**SITE PLAN REVIEW SHEET  
ENVIRONMENTAL VARIANCE REQUEST ONLY**

**CASE:** SP-2016-0420D

**PROJECT NAME:** Bulkhead for 2200 Lauranne Lane

## MEMORANDUM

*Exhibit 1*  
*CWQZ & Topography*  
*Bulkhead for 2200 Lauranne Ln.*  
*SP-2016-0420D*

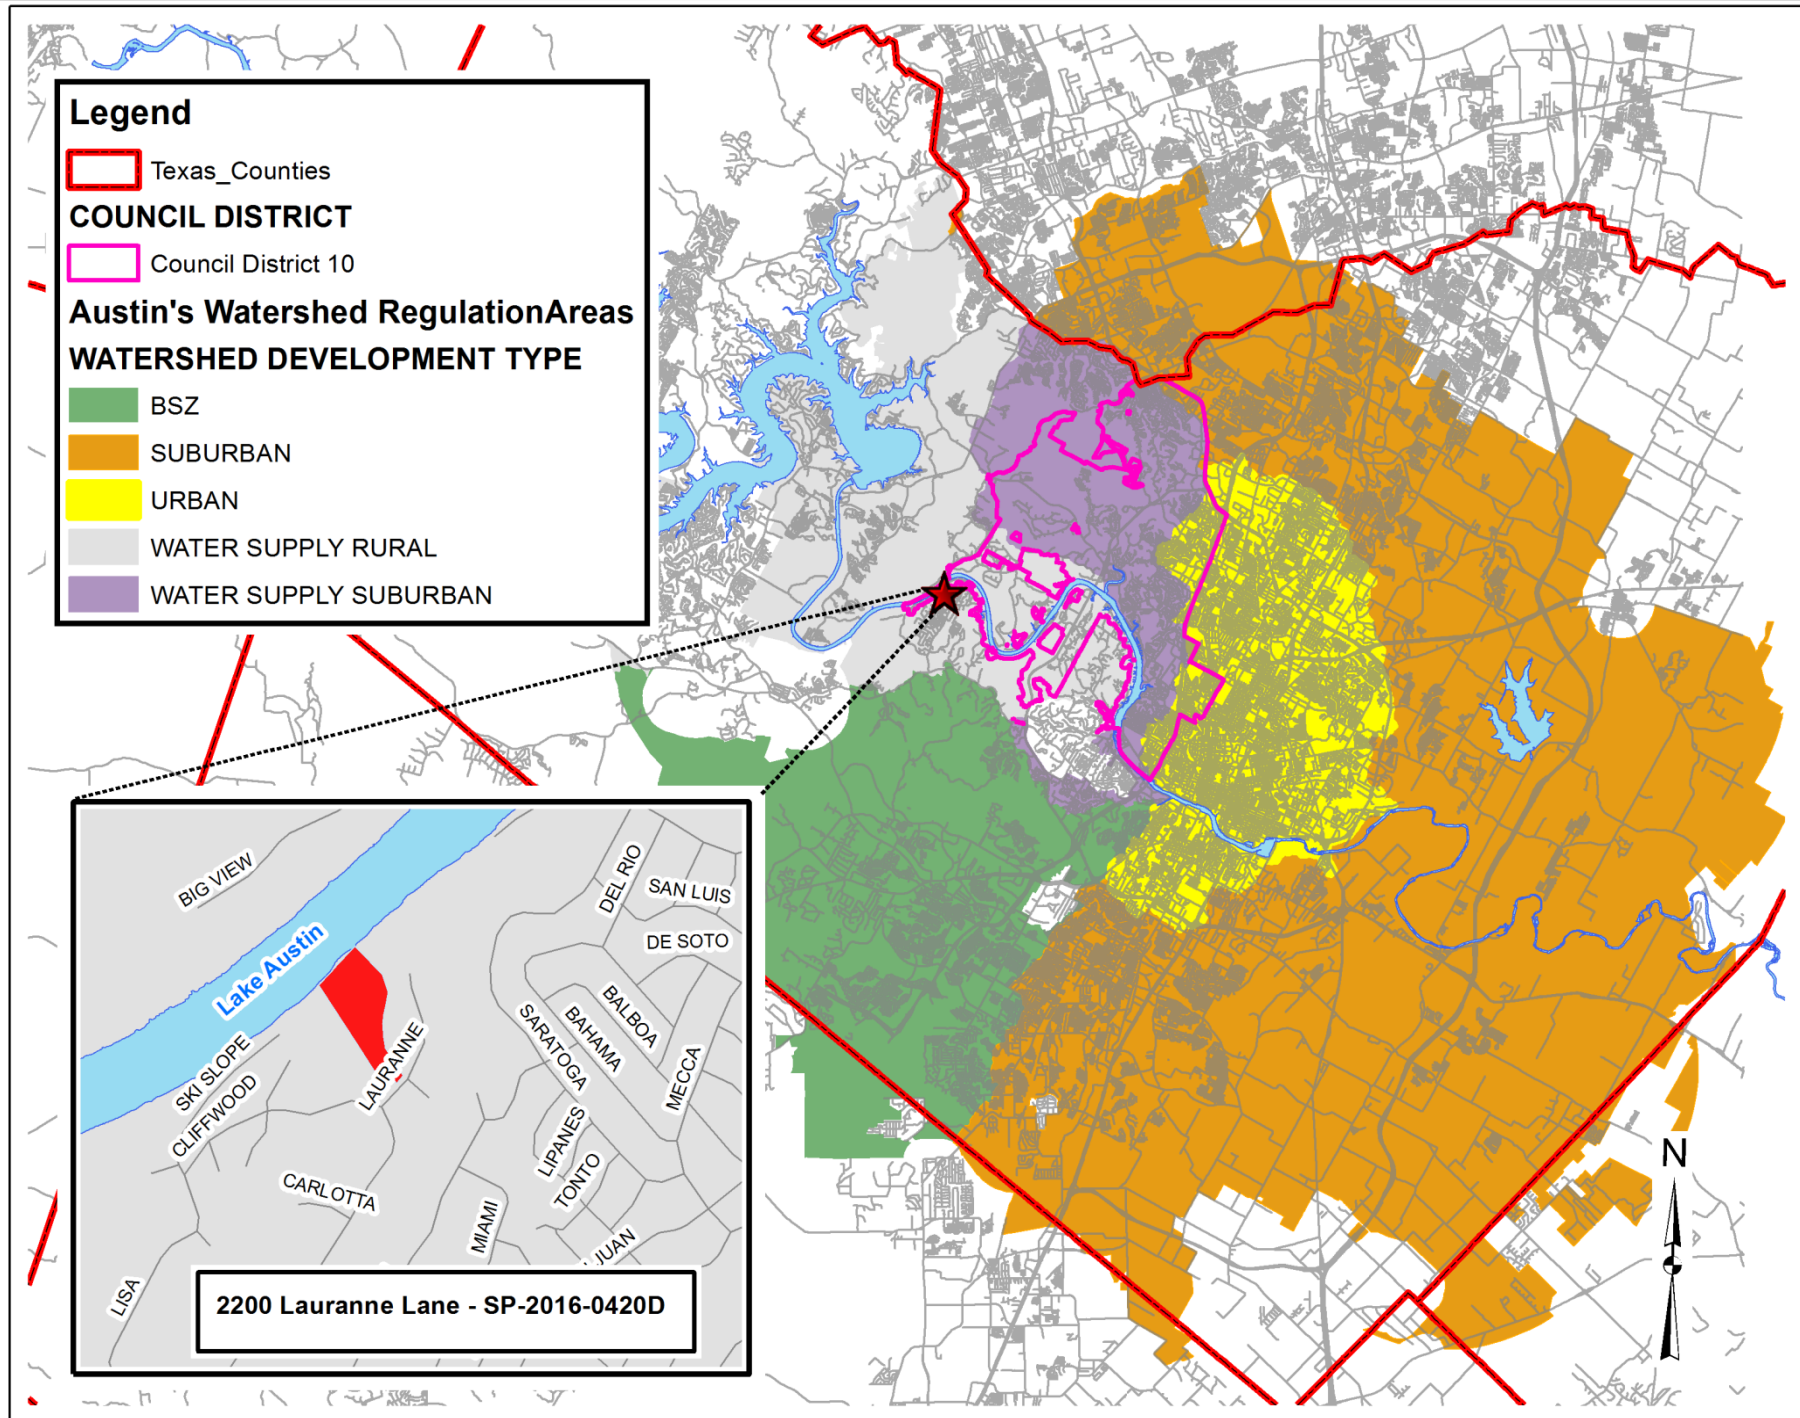
A Critical Water Quality Zone associated with Lake Austin extends onto the property (Memo Exhibit 1 – Critical Water Quality Zone and Topography Map). The property is located within the Lake Austin Watershed, which is classified as a Drinking Water Protection and Water Supply Rural Watershed. The property is not located within the Edwards Aquifer Recharge Zone. The property fronts Lake Austin, and surface water drains northwest to Lake Austin.

EXHIBIT 3  
SITE PLAN  
BULKHEAD FOR 2200 LAURANNE LANE

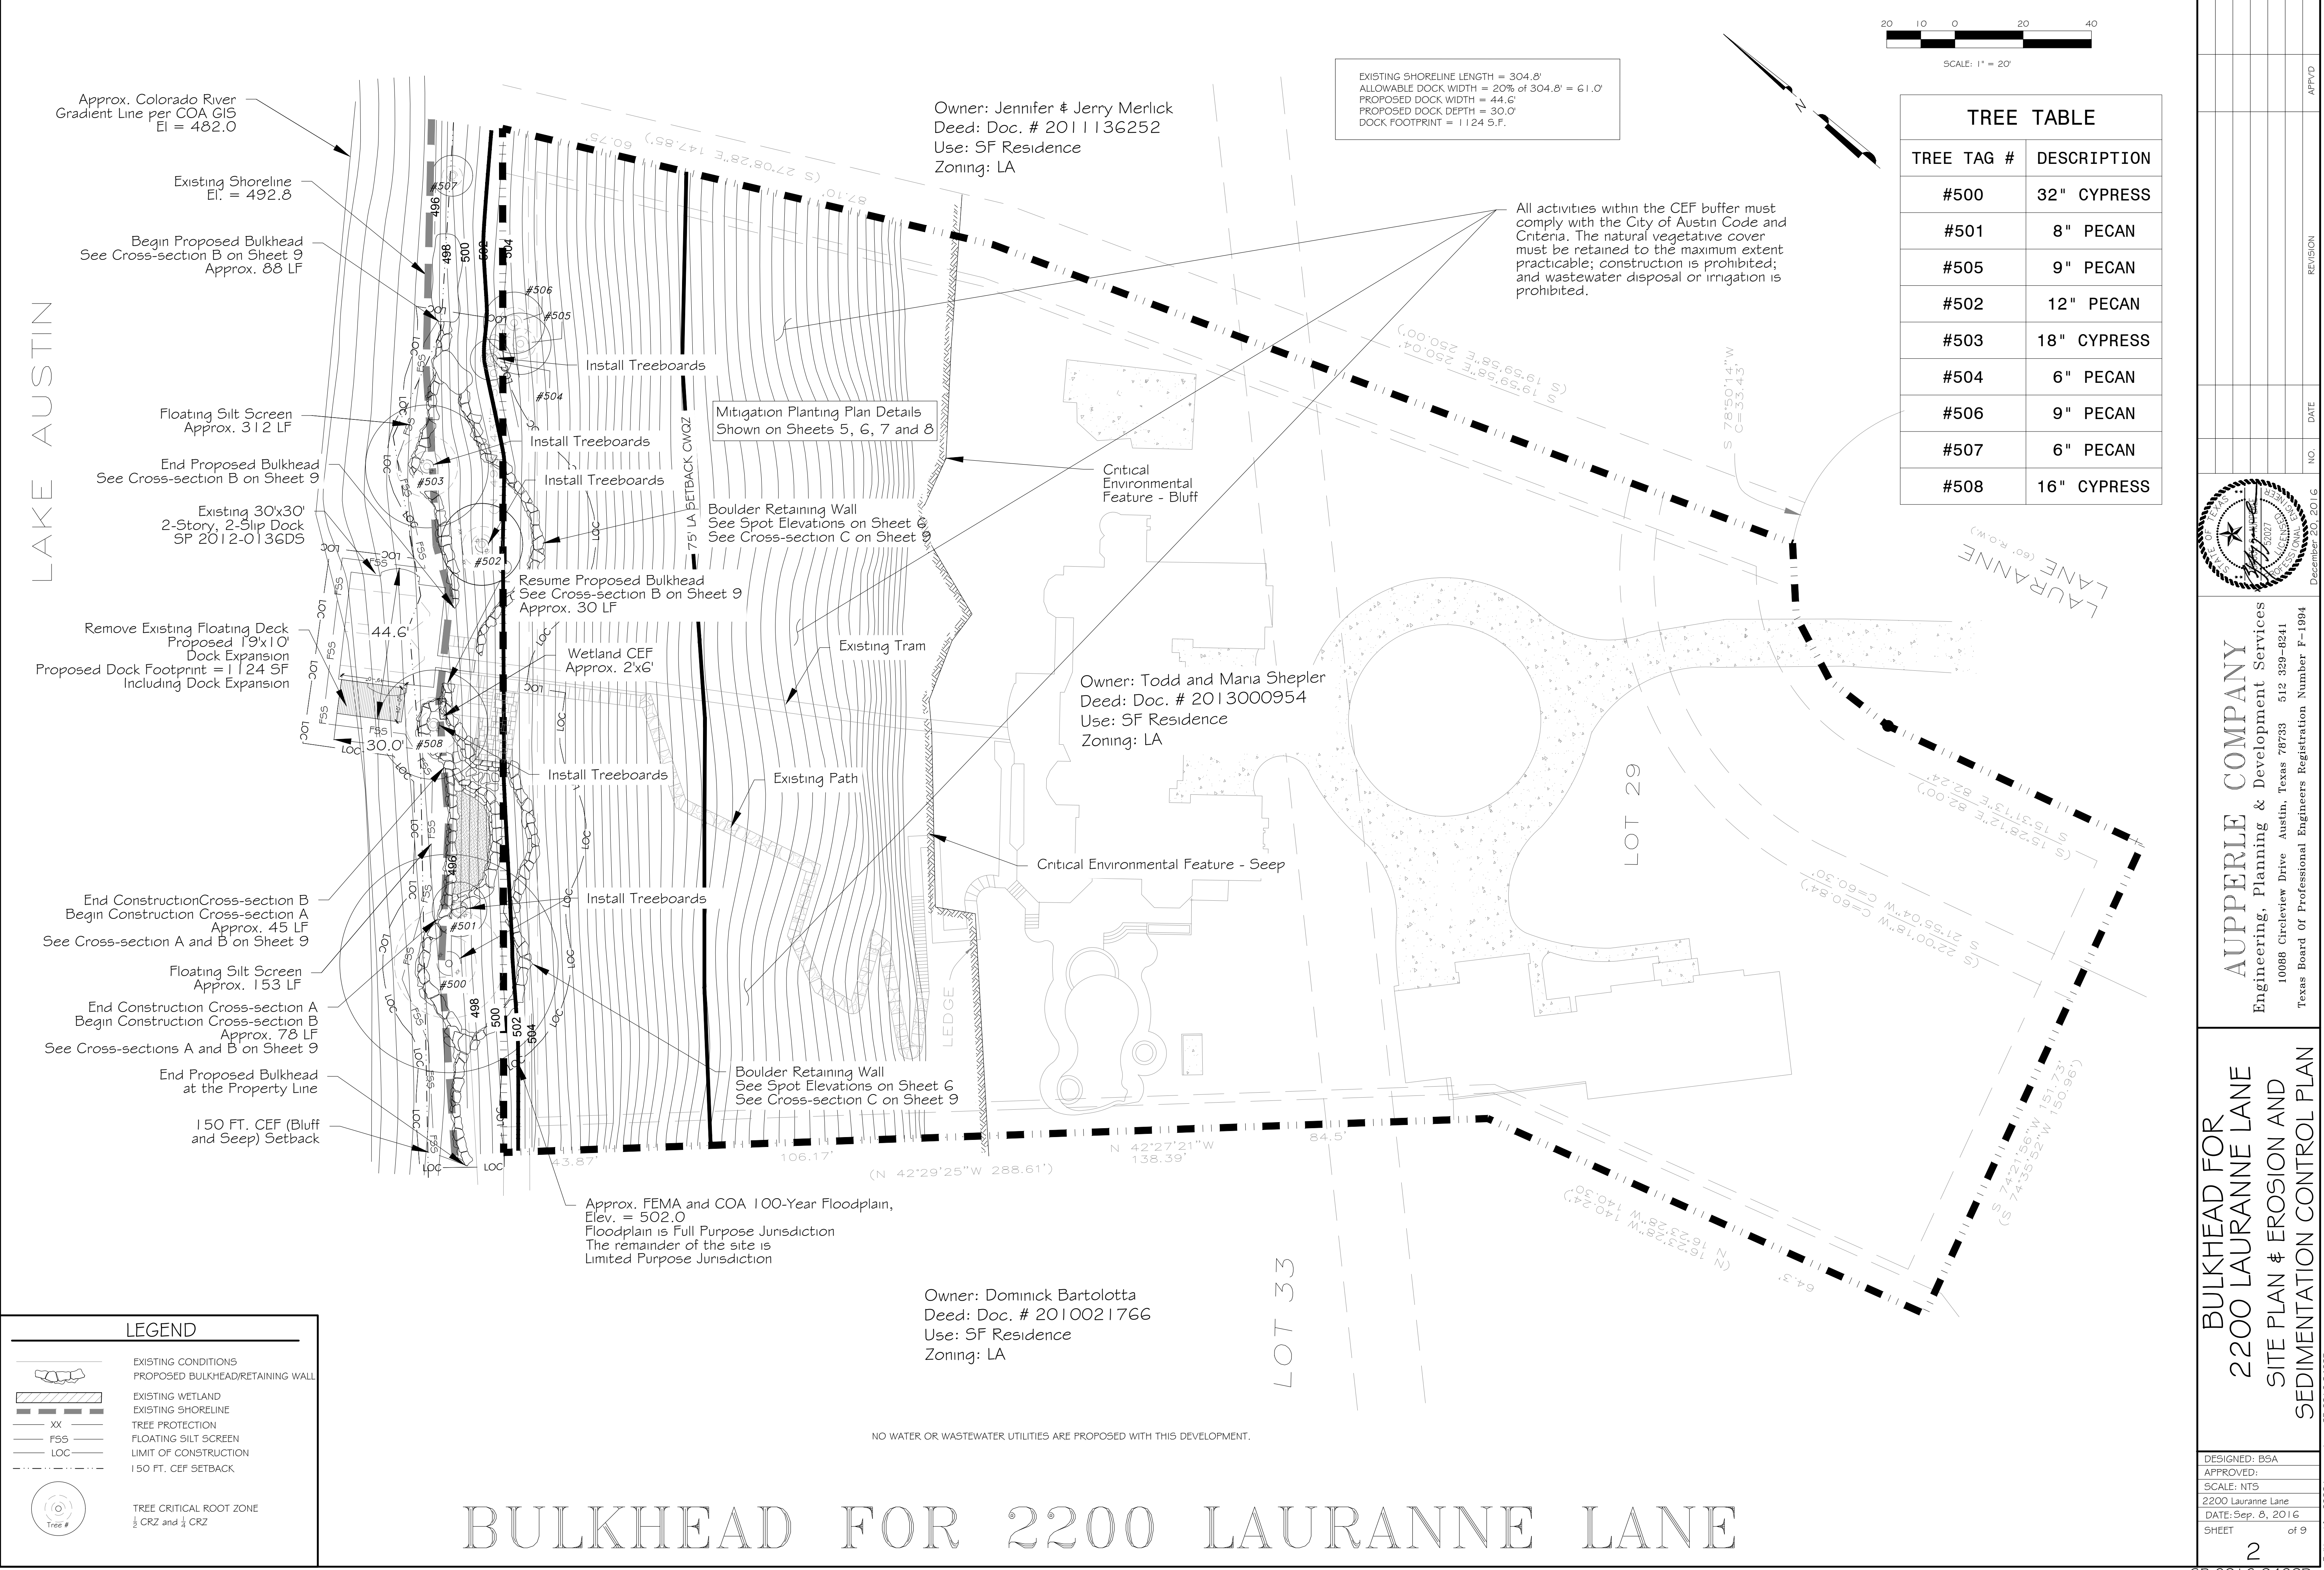
The proposed project, consisting of tiered, limestone and riprap walls, is downhill of and within the 150' setback of the rimrock and seep. The project is necessary to stop erosion along the bank that is threatening multiple trees and is designed to protect the trees. At the point closest to the rimrock and seep, the wall is 111 feet downhill from the CEF.

LDC 25-8-281(C)(2)(b) prohibits construction within a critical environmental feature buffer zone. The applicant is seeking a variance to allow construction of a bulkhead and shoreline stabilization within the critical environmental feature buffer for the canyon rimrock.

**Conditions for Staff Approval**

All work will be done from the lake, by barge.

The Findings of Fact have been met. Staff recommends approval of the variance with the above condition.
